Administrative Approval Action

**Case File / Name: ASR-SR-105-2018
2019 FAIRVIEW**

REQUEST: Development of a 0.35 acre/15,457 sf tract zoned OX-3-DE from an existing office building, which will be demolished, into a proposed 4 unit-3 bedroom, 3 stories multifamily apartment building. The overall gross floor area for the structure is 14,930 sf (Unit A being 3,657 sf; Unit B - 3,621 sf; Unit C- 3,621 sf; and Unit D - 4,031 sf). The net site area .34ac/15,006 sf after a right-of-way dedication of 451 sf/.01acres.

ADMINISTRATIVE SITE REVIEW

A300

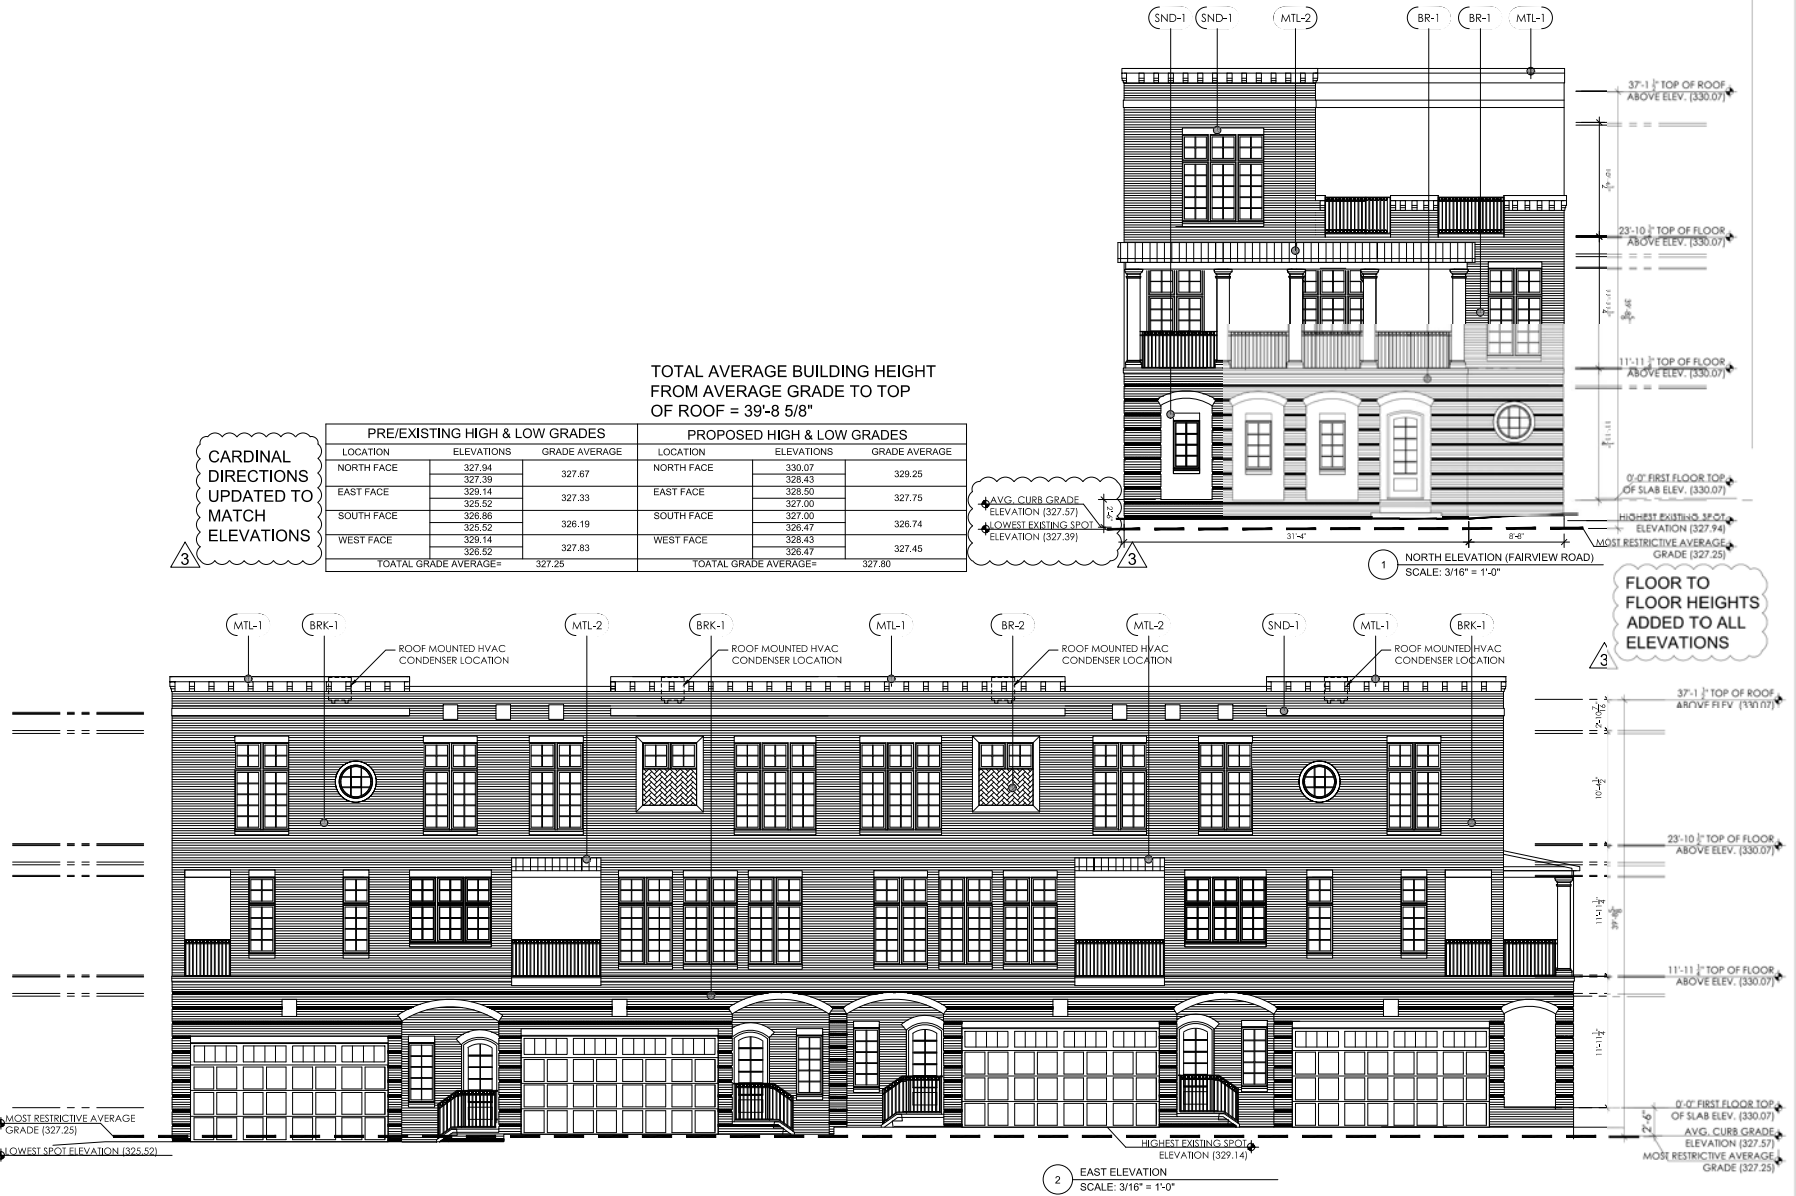
CARDINAL
DIRECTIONS
UPDATED TO
MATCH
ELEVATIONS

FLOOR TO FLOOR HEIGHTS
ADDED TO ALL
ELEVATIONS
